Architectural Review Board Agenda  
4:00 PM Wednesday, December 4, 2024  
Sussex Civic Center – Committee Room Second Floor

TO: Architectural Review Board  
FROM: Gabriel Gilbertson, Community Development Director  
RE: December 4, 2024 Architectural Review Board  
DATE: Wednesday, November 27, 2024

- I. **Roll call.**
- II. **Consideration and possible action on the ARB minutes of August 7, 2024.**
- III. **Consideration and possible action on the site plan, architectural plan, lighting plan, landscape plan for Bubbles Foam Farm car wash located at the property identified by Tax Key Number 231.997.014 in the B-3 Highway Business Zoning District.**

SHEET TITLE:  
SITE LIGHTING PHOTOMETRIC PLAN

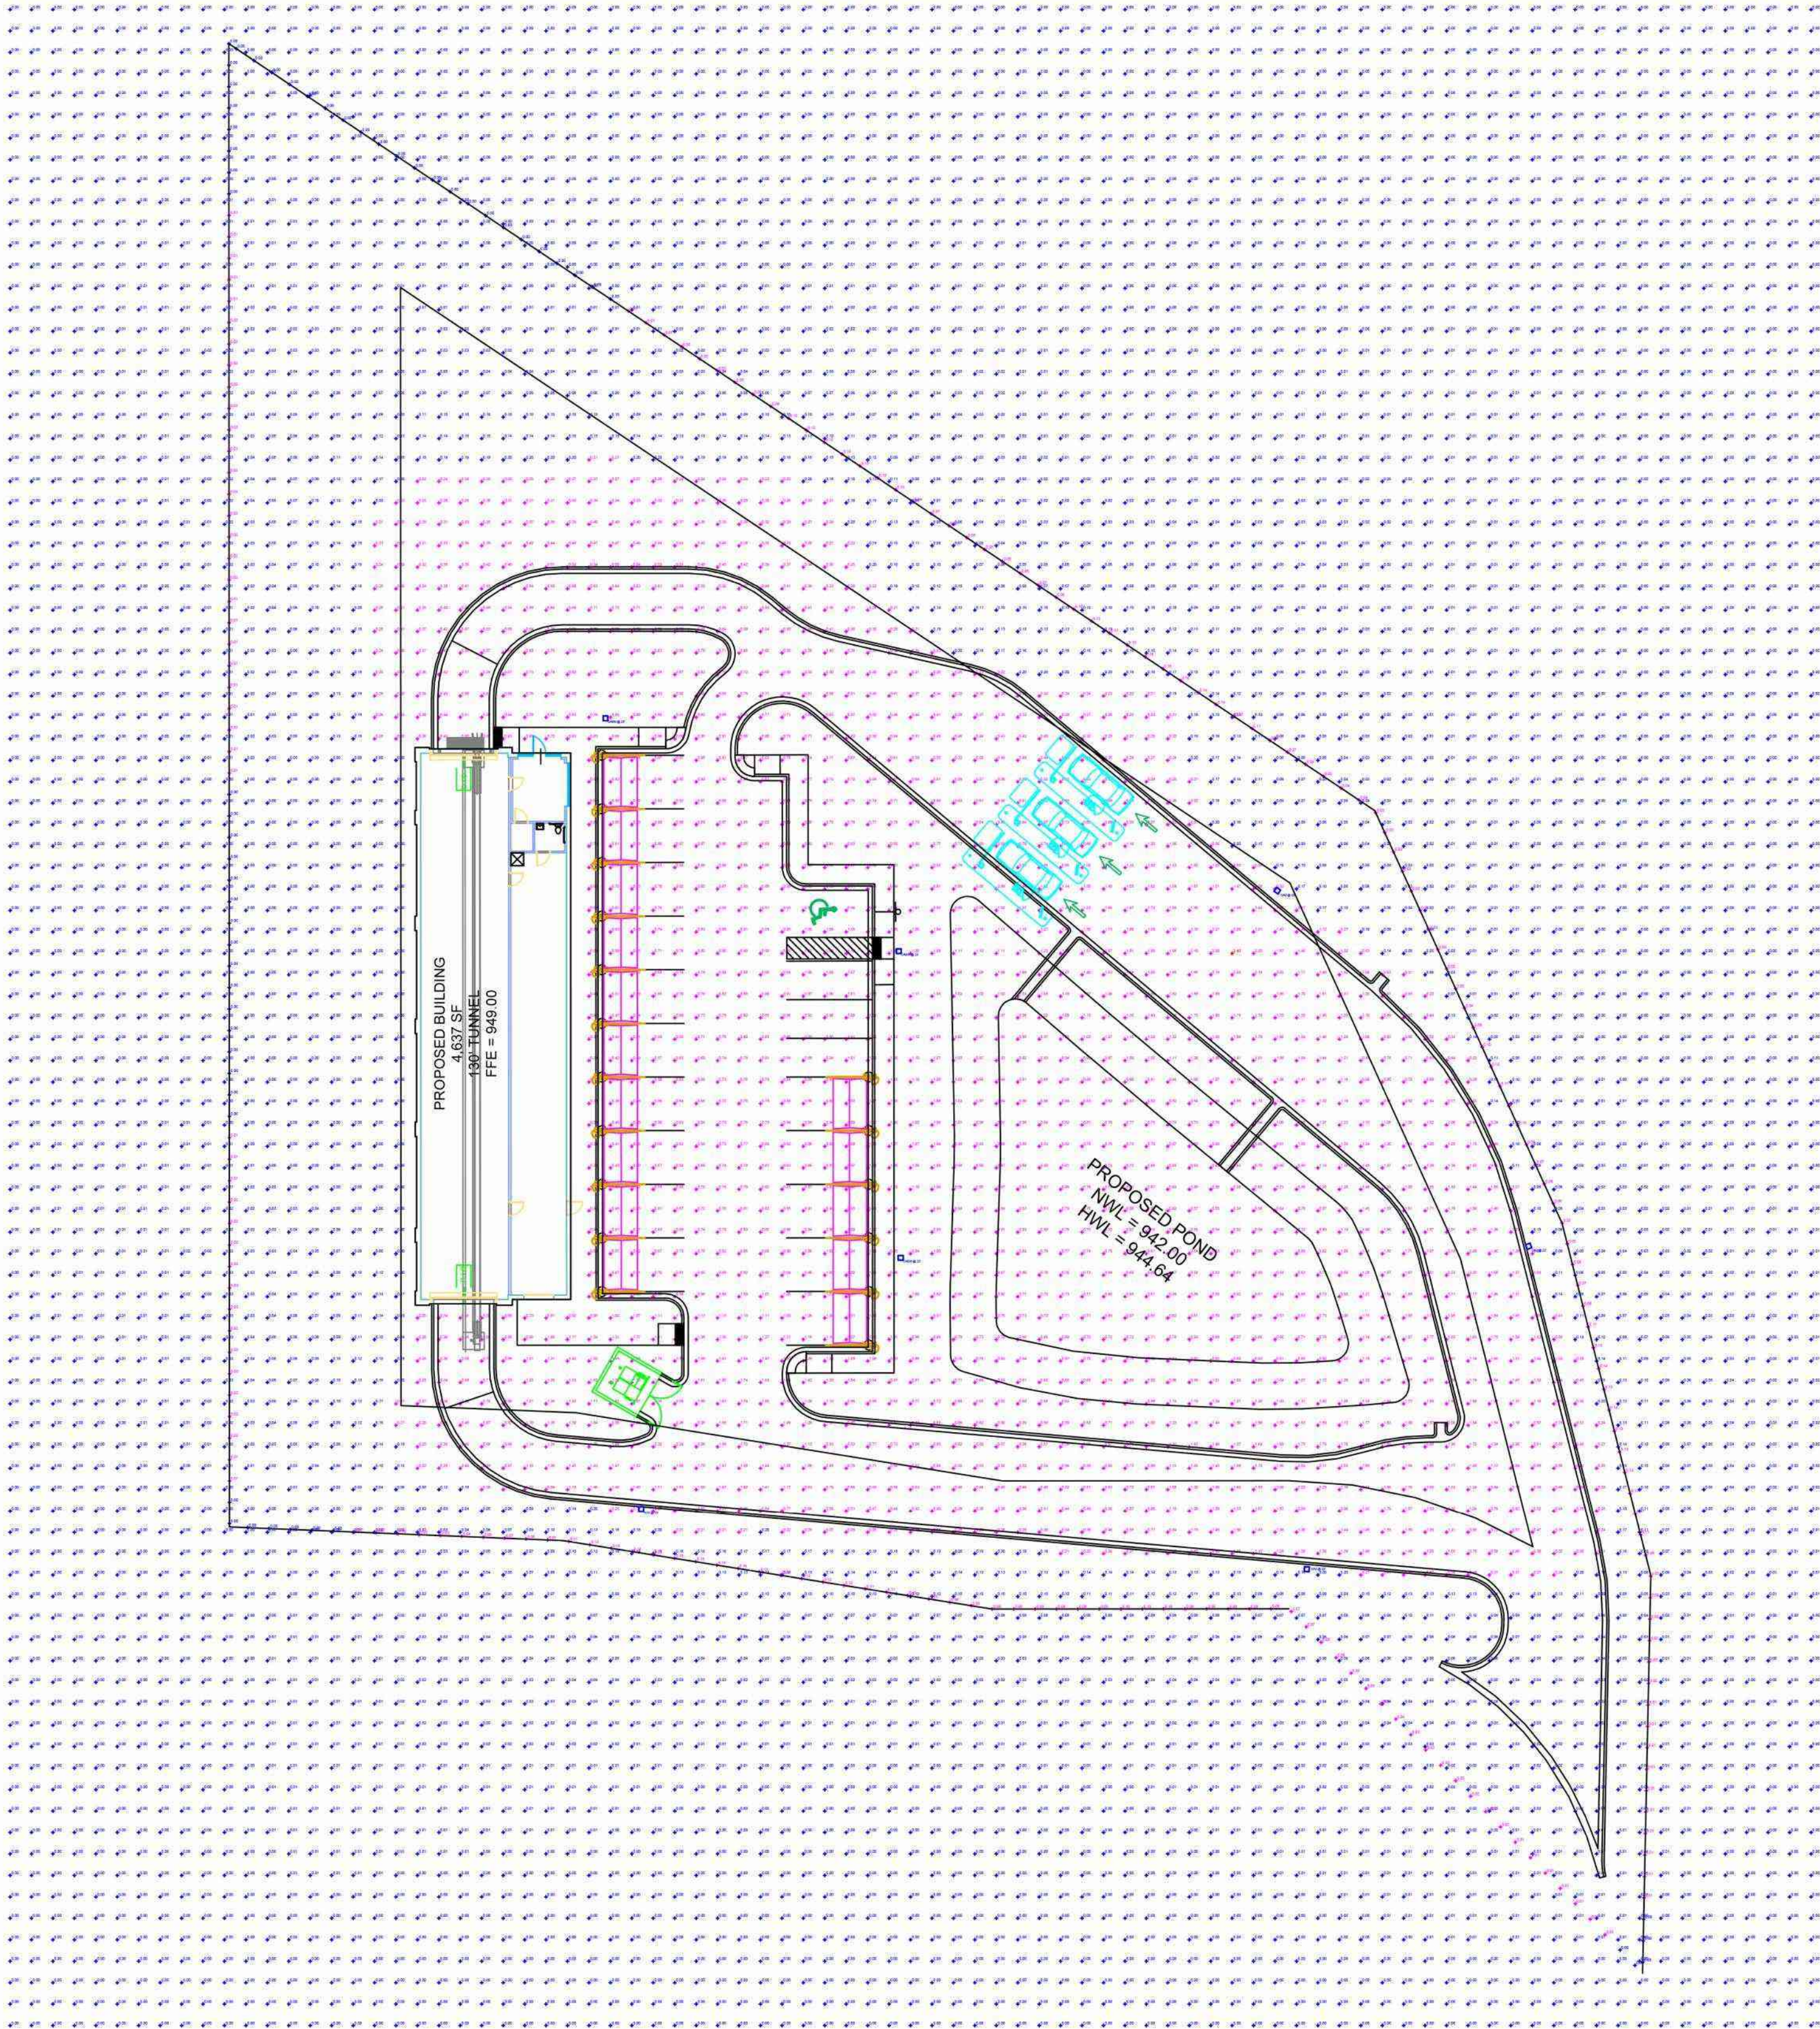
- The submitted lighting plan is very blurry and difficult to determine if there is light spilling on to adjacent properties. The details mention bases. If the poles are to have bases, they will need to be painted to match the building.

LANDSCAPE GENERAL NOTES & DETAILS FOR REVIEW ONLY 6 COPYRIGHT 2023 www.pinnacle-engr.com

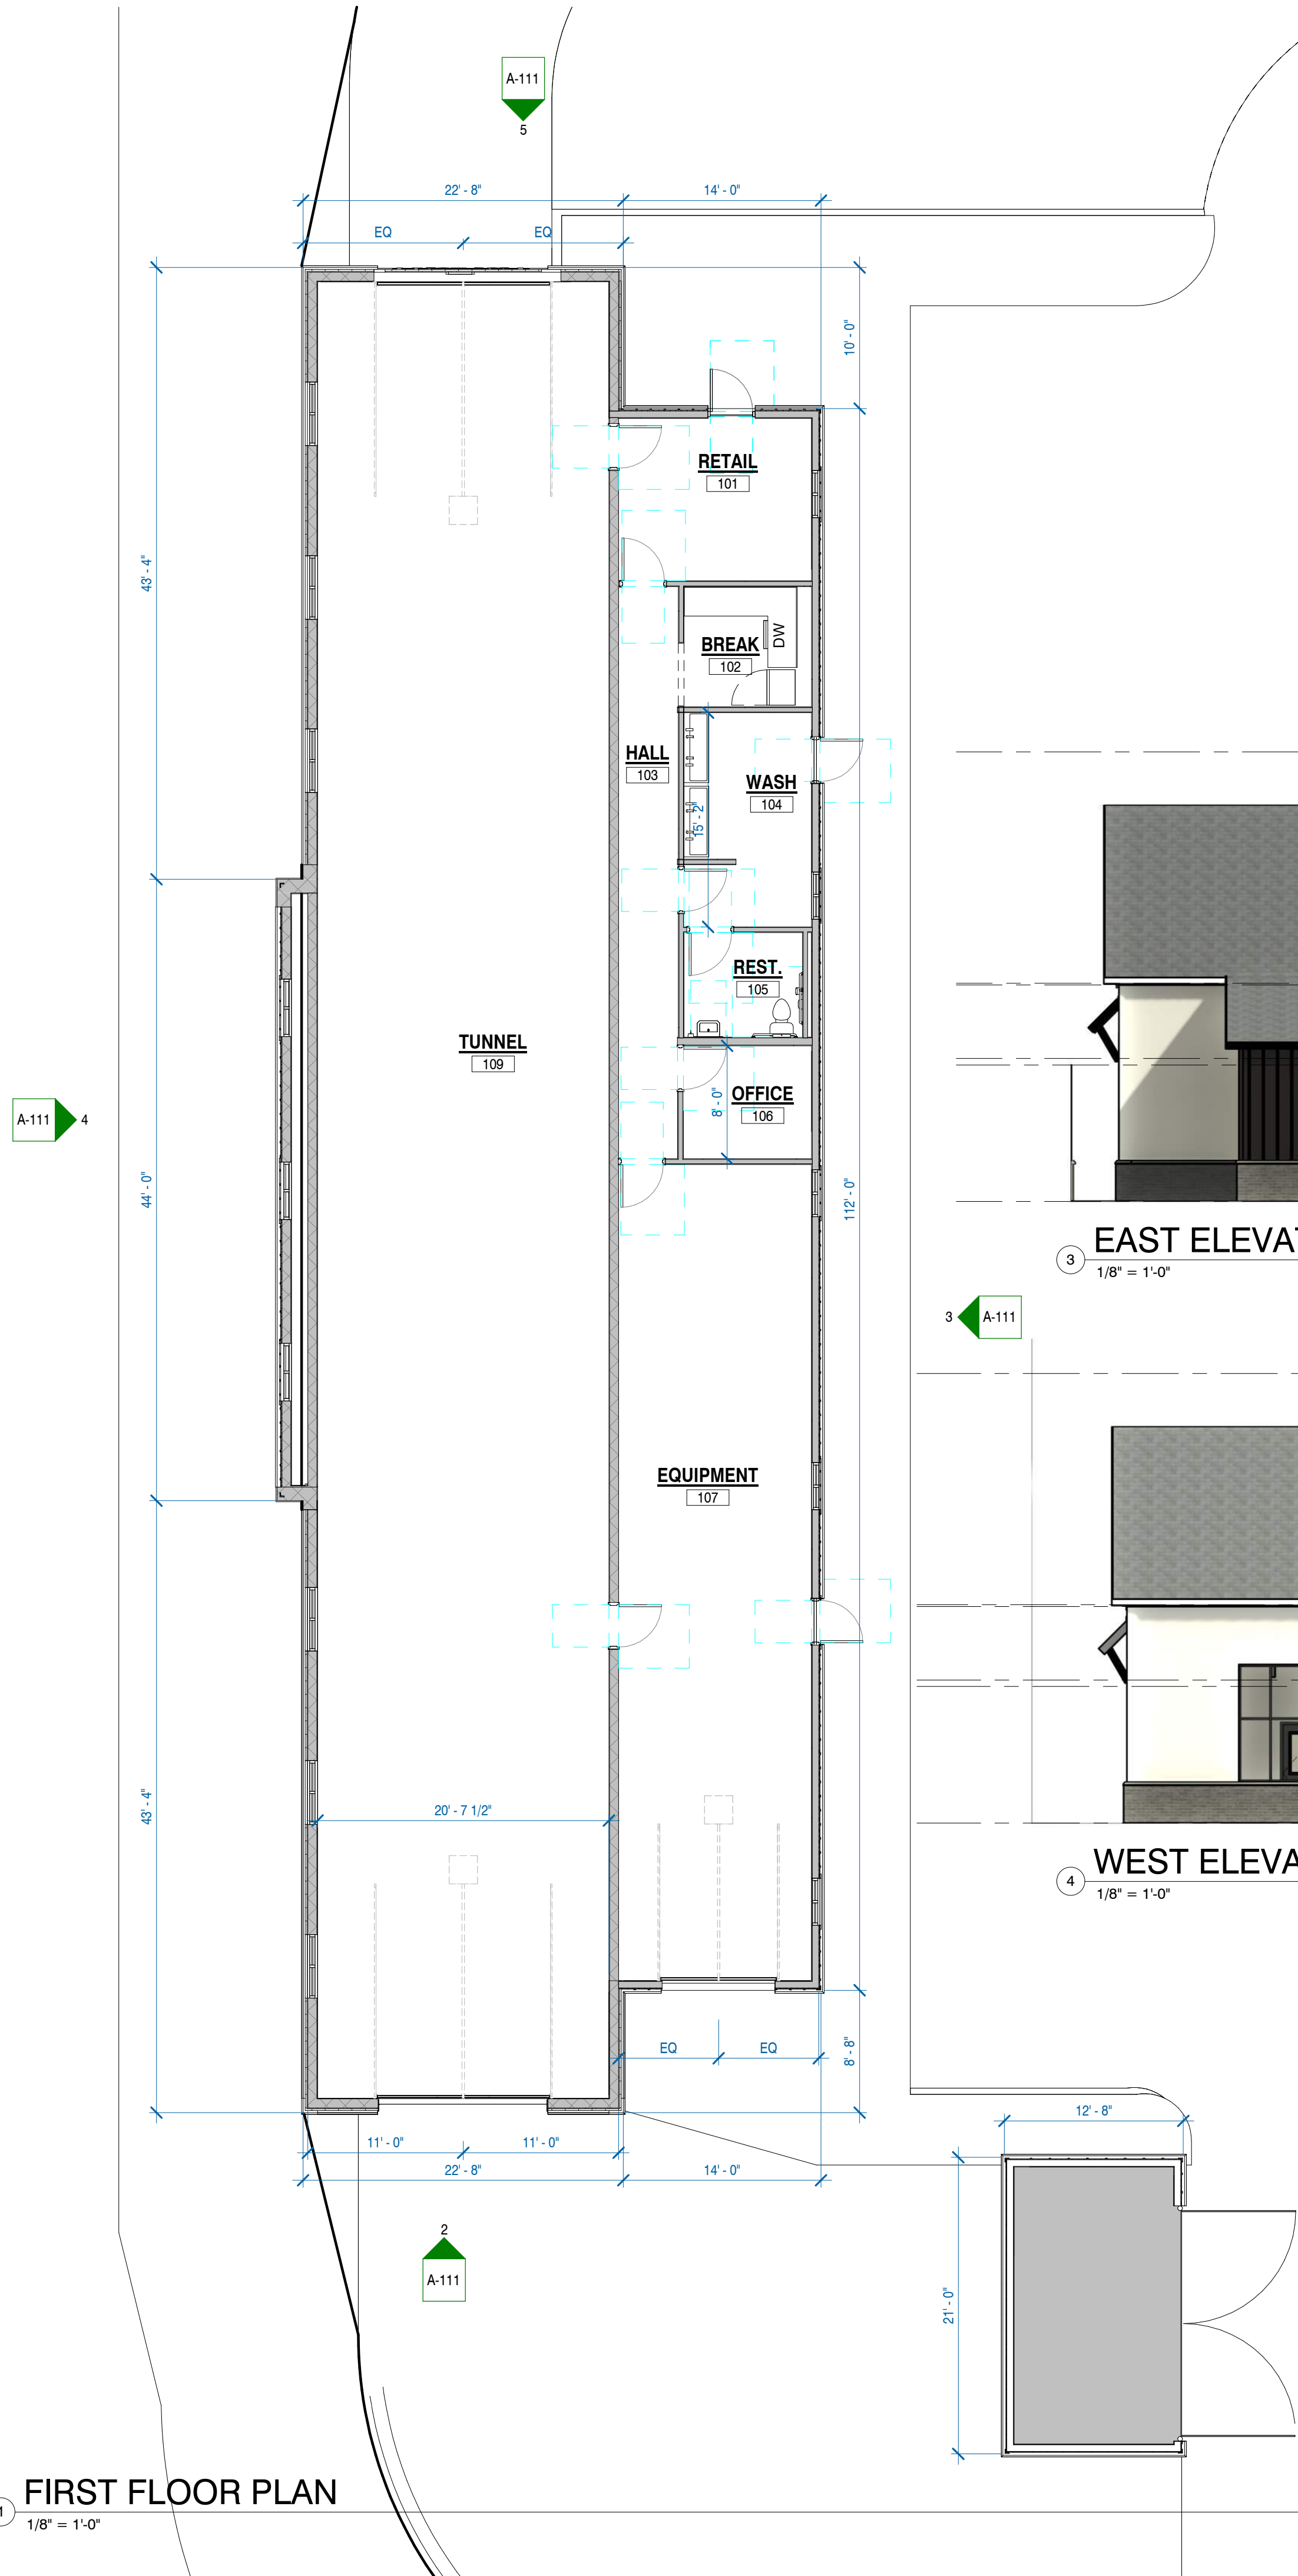
- Staff has requested the applicant to include planting counts on the landscape plan to ensure it at a minimum meets the previously approved number of 15 trees, 132 shrubs/grasses, and 88 perennial flowers. The site needs additional evergreen trees in the northern corner to provide additional screening from the multifamily development to the north and to bring the site in closer to the required number of trees as part of the landscape buffer requirements and as required by the previous approval of the site.

1. Submitting a revised landscape plan that includes the following:
  - a. Addresses the inconsistencies between the site plan and the landscape plan where the dumpster enclosure is located.
  - b. Includes the additional evergreen trees at the northern corner of the property that were requested with the original approval of the Mr. D carwash development.
  - c. Includes planting counts to ensure it meets the minimum numbers of the previously approved landscape plan.
